SUBJECT: Amendment Request for Certificate of Compliance No. 9168 for the  
Model 8-120B Package - Request for Supplemental Information  
Docket No. 71-9168  
TAC No. L24549

EnergySolutions provides the attached response to the second request for additional information (RAI) dated 28 March, 2012.

Figure 5.2 – HAC Cask Model

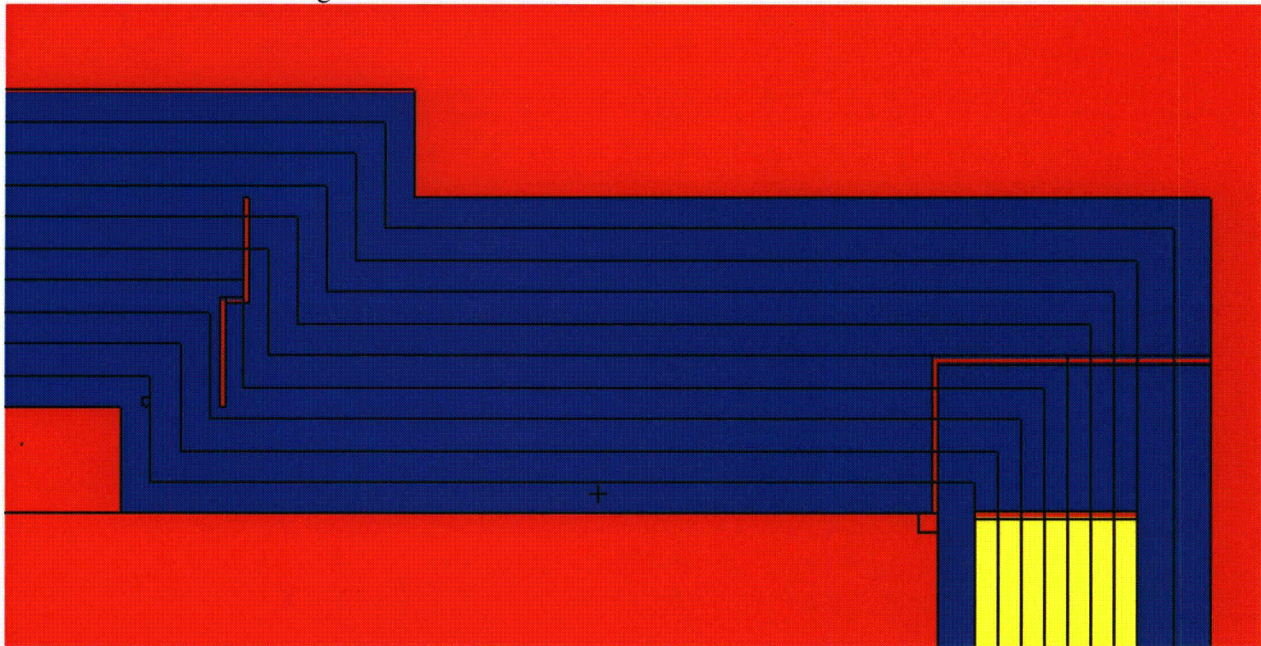
*The staff could not verify these numbers from calculations presented in ST-627 Rev. 1, nor from calculations in ST-679 Rev. 0. These values were further used in the modeling of the shielding of the package. Provide details of how these numbers were derived, and indicate where these numbers can be found in each of the two calculations mentioned above.*

The response to RAI #2-1 states that the structural analysis shows lead slump due to the drop is 0.141". The value 0.15" has been conservatively included in the HAC shielding model to account for the lead slump.

The structural analyses show that local radial lead shielding thinning due to the HAC puncture drop will not exceed 0.5 inches. The HAC shielding analyses conservatively address this potential effect by reducing the thickness of the entire radial lead shield by 0.5 inches.

**Figure 5.5 - Payload Gamma Source Strength Density Limit vs. Gamma Energy**

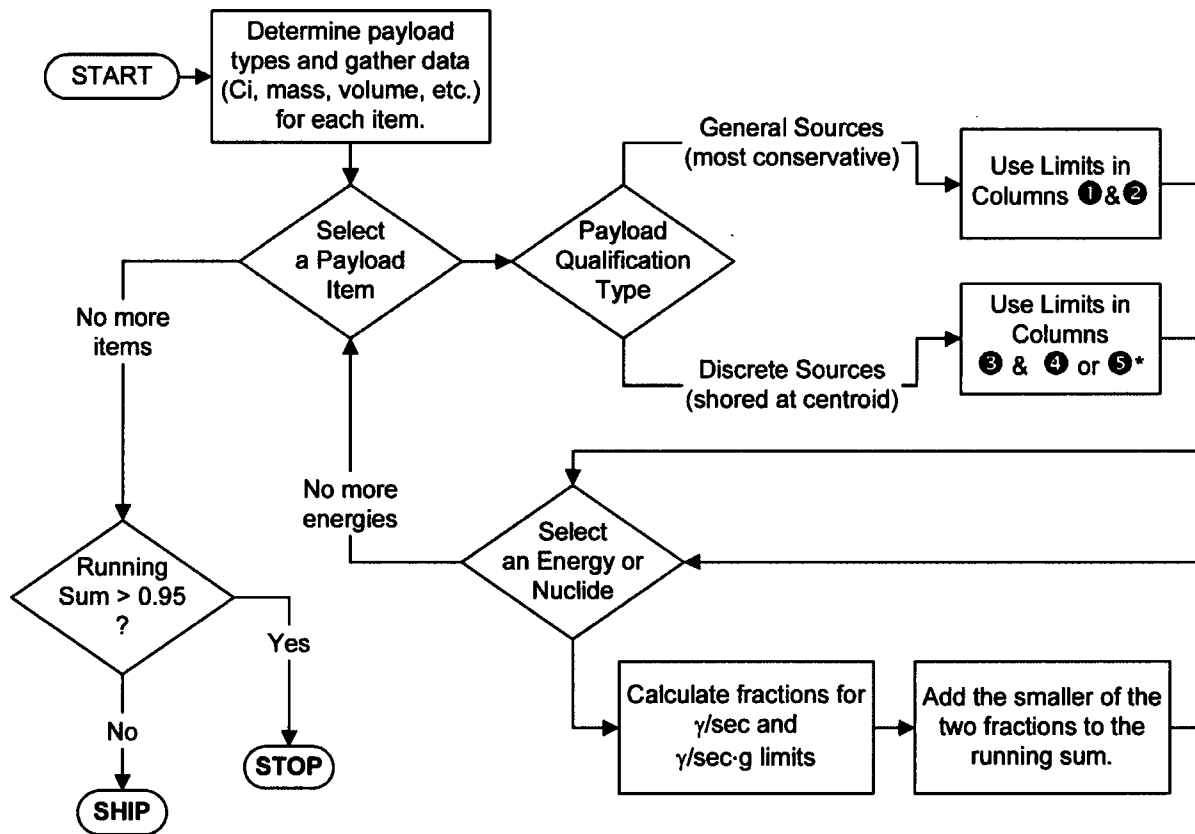
*Regarding item c, Figure A-2 allows for a precision of 0.05 for the DCF and 0.5 for payload density, while the precision of the limits from Figure A-1 is limited due to the logarithmic scale. For item d, staff noticed that some limit values (and DCF values in applicable examples) don't match the values derived from the attachments figures. For example, the values for energies below 0.5 MeV don't match the limit for 0.5 MeV (as they should per the Attachment 1 procedures). All the limits in the examples should be verified versus the figures since many appear to be incorrect. Also, some DCF values appear to be high for some energy levels due to rounding up or due to that energy being between the energies shown in Figure A-2; the conservative approach would be to round down or use the lower DCF from the plotted energies. The procedures should be clarified to address these aspects too. For item e, staff noticed that the activity for energy group 4 in example 2 appeared to be lower than it is and energy group 8 in example 4 is missing the converted beta (to gamma) source from Y-90. The applicant should ensure the examples are correct since a package user may rely on them to guide its determination of acceptance of the contents in a given shipment. This information is required to demonstrate compliance with 10 CFR 71.81.*

*Figure A-2 of the application does not include densities below 0.5 g/cc. However, the curve indicates the DCF value would drop significantly if it were extended to lower payload densities. Thus, it would be non-conservative to use the DCF at a density of 0.5 g/cc for payloads with lower densities. If payloads with lower densities are not shipped, then the procedures could be modified to limit allowable payloads to those with densities of 0.5 g/cc and above.*
